Technical Service Information

ACURA/HONDA DIFFERENTIAL CROSS SHAFT FAILURE

Figure 1

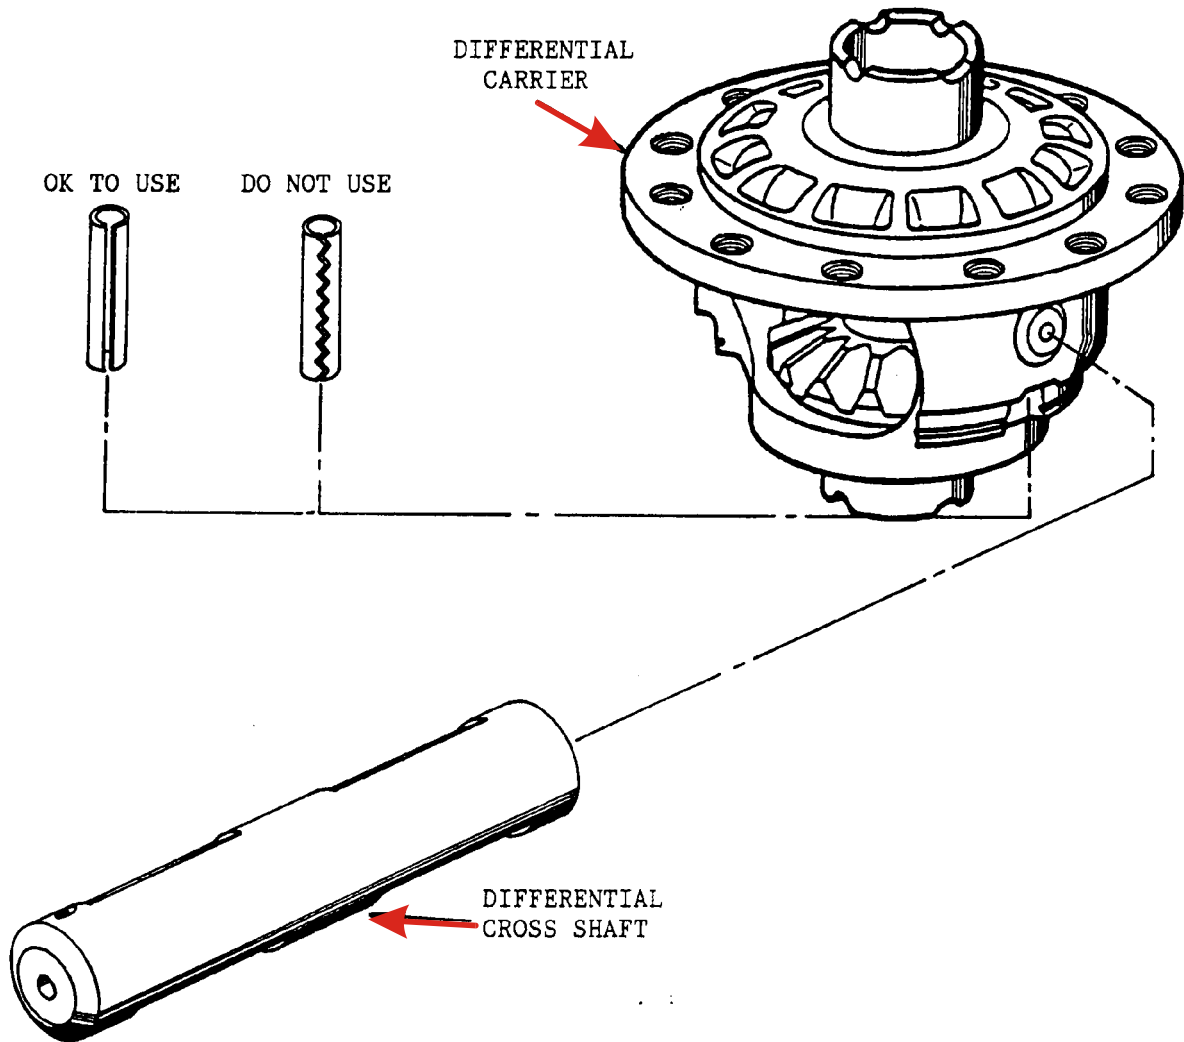
COMPLAINT: Failure of the differential cross shaft that resembles a lubrication failure, in the area of the cross shaft where pinion gears rotate.

CAUSE: The cause may be the material from which the cross shaft was made.

CORRECTION: There is now available from Honda, two new design differential cross shafts made of Titanium, that will eliminate the above complaint and should be installed during routine overhaul (See Figure 1). The rolled pin that retains the cross shaft in the differential carrier should also be replaced with a different design. The original rolled pin, with the split that resembles a "Zipper" (Figure 1), should NEVER be used. ALWAYS replace it with a regular split type rolled pin of the proper dimension.

Refer to the chart in Figure 1 for the dimensions and part numbers for the new design differential cross shafts.
